**Response to Comments on the Draft Response to Submissions – Edge Estate (SSD-17552047)
141-251 Aldington Road, Kemps Creek**

Table 1 Response to Comments on Draft Response to Submissions

Figure 1 Dedicated Freight Road Annotated Drawing

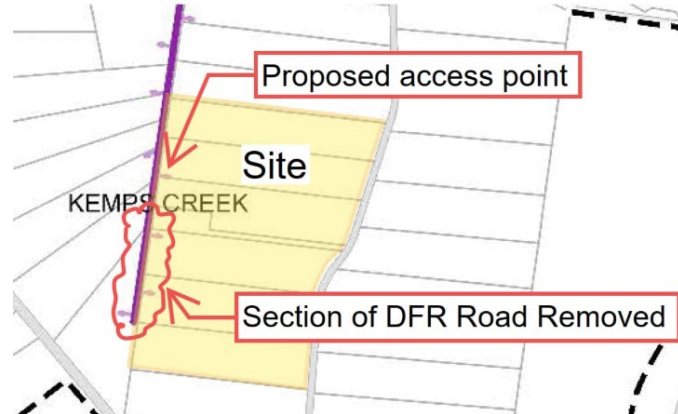
7. Clarify how the proposed single access point to the dedicated freight corridor within Lot 2 will enable access for the rest of the development and how the proposed design supports the objectives of section 3.4.2 of the MRP DCP and the functioning of this corridor.

As outlined in the Civil TOA Response (**Attachment B**), Section 3.4.2(5) of the MRP DCP states, "Development applications for lots with an identified access point (refer Figure 17) shall demonstrate how access to and from the dedicated freight corridor will be achieved."

The section of the dedicated freight road to the south of Road No.1 (located on the Access Logistics Estate) has been excluded from the reference design after consultation with TfNSW (refer to **Figure 1**). As a result, a single access point to the site is identified by the MRP DCP (refer to **Figure 1**). The Applicant has provided the subject access point from Lot 2 to the dedicated freight corridor and therefore complies with the controls and objectives of the MRP DCP. Furthermore, TfNSW have endorsed the "Functional Layout design" which is consistent with the provided dedicated freight road civil drawings.

Figure 2 Predicted dispersion of construction particulate emissions – Scenario 1

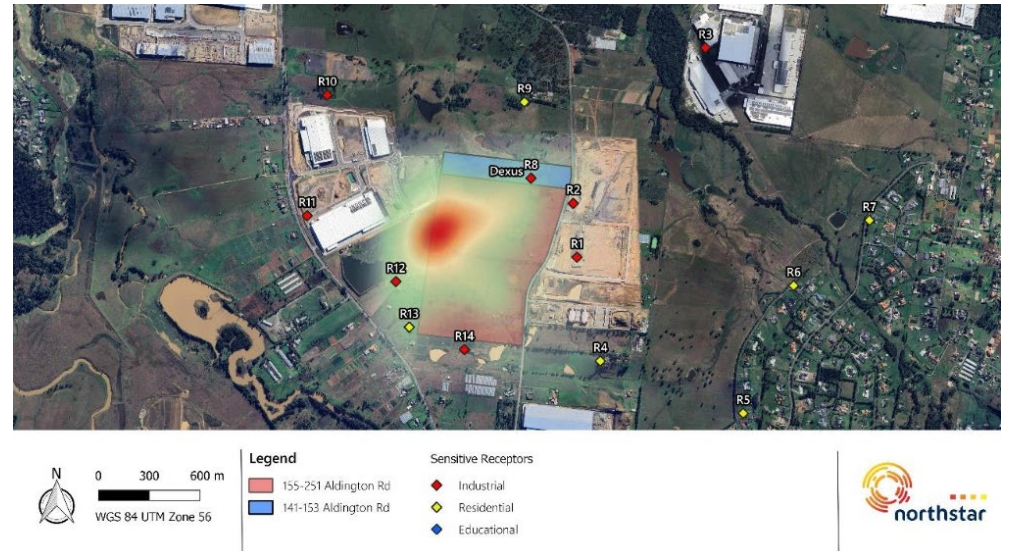
1. The Department has received advice from an independent air quality expert, which identified shortcomings in air quality assessments in the MRP. Please address the following points in a revised AQIA:

- Monitoring particulate matter leaving the site boundary and potentially impacting nearby receptors is an important part of air quality mitigation measures for the development. High-level modelling is required to understand the local dispersion patterns and determine the most suitable upwind and downwind monitoring locations. The difference between the upwind and downwind monitors allows the calculation of the site contribution.

The predicted dispersion of particulate matter emissions for Scenario 1 and 2 is provided in **Figure 2** and **Figure 3** respectively.

In summary, construction particulate matter emissions are predicted to travel and be more concentrated along the western boundary of the site and it is considered that real-time monitoring should be performed towards that location to allow calculation of downwind impacts along that boundary.

As such, Northstar Air Quality has recommended real-time monitors be positioned on the western as well as the eastern boundary to inform the Trigger Action Response Plan (TARP).

The monitors should be located centrally on the western and eastern boundaries in Scenario 1 and moved south in Scenario 2.

Westgate Proposal (Civil Plan no 21-860-C004)

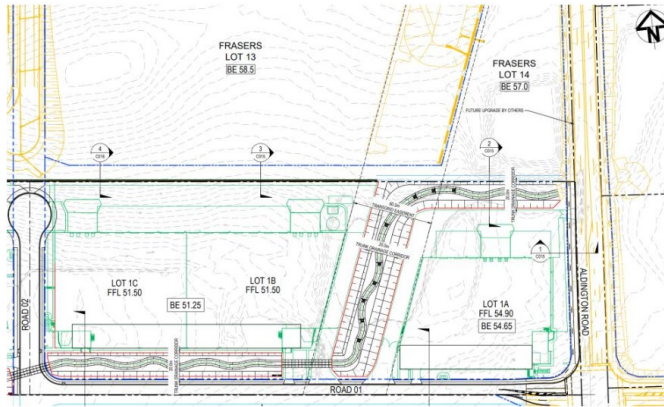
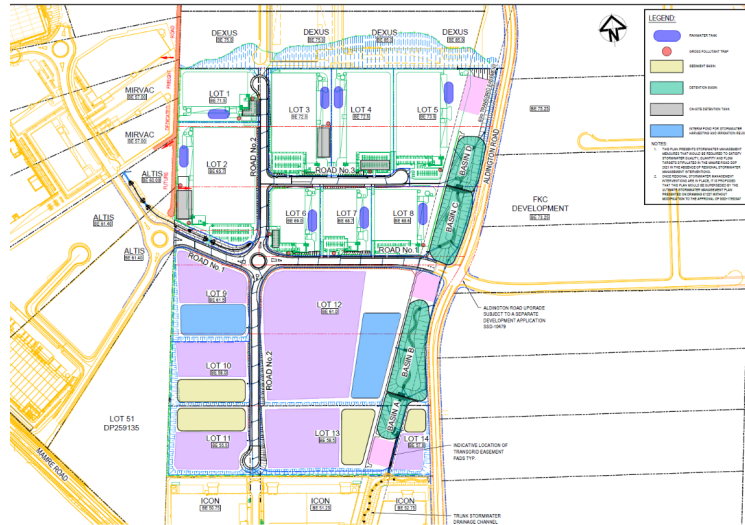
2. Should the Edge Estate precede Westgate, the Civil Response provides that 'an interim outlet arrangement incorporating a tailout into the existing farm dam would be required. This detail would be subject to further coordination between Frasers and Icon Oceania'. Please include details of the interim tailout, including civil drawings and Icon Oceania's agreement to allow water to be discharged into the existing farm dam in its landholding.

Frasers Property Industrial and Icon Oceania have and will continue to coordinate key civil design aspects. A Coordination Letter has been prepared by Icon Oceania (**Appendix W** of the Submissions Report) that provides evidence of the ongoing commitment between the landowners to provide the practical interim and ultimate engineered solutions.

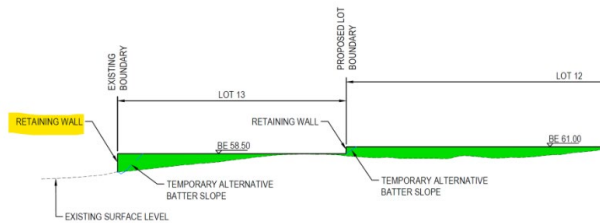
1. The Department notes a retaining wall of approximately 7 m high is proposed between the finished pad levels at Lots 13 and 14 and the Westgate Kemp's Creek development to the south (see below). The retaining wall does not comply with control 17 in Section 2.4 of the MRP DCP requiring 'high vertical walls and steep batters shall be avoided retaining walls shall not exceed 2.0 m in cumulative height'. Additionally, retaining walls must be set back at least 2.0 m from the property boundary in accordance with Section 4.4.1 of the MRP DCP. Please provide a revised design that complies with the MRP DCP.

The subject retaining wall is approximately 5m high. Refer to 20-776-C1082 and 20-776-C1086 (Retaining Wall MW05) of the updated Civil Drawings (**Appendix E** of the Submissions Report).

The retaining wall along the southern boundary directly interfaces with the trunk drainage channel located on the Icon Oceania site which forms part of the regional stormwater network. The design for the subject trunk drainage channel has received in-principle support from Sydney Water (refer to **Appendix V** of the Submissions Report). The trunk drainage channel includes landscaping that will screen the proposed retaining wall with landscaping to be planted at the top of the wall (within development lots) in accordance with the MRP DCP as part of the future development.

Figure 4 Revised Trunk Drainage Channel Design

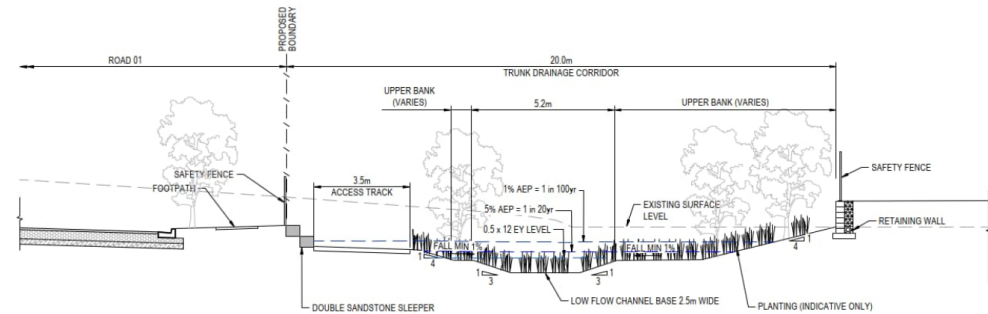
2. The Civil Response states that 'detailed design of the retaining walls between the trunk drainage channel and Lot 2 will continue to be developed in consultation with Sydney Water and will ensure compliance with the DCP controls for retaining walls'. Please provide detailed design of the retaining wall as part of the RtS considering bulk earthwork of Lot 2 forms part of the proposed development.

As outlined in the Civil TOA Response (**Attachment B**), AT&L and Barings are working with Sydney Water to finalise the design of the open Trunk Drainage Channel. As part of this revised design (refer to **Figure 4**), Lot 2 has been lowered which will further reduce the retaining wall along the northern side of the channel. The wall adjacent to Lot 2 is compliant with the MRP DCP.
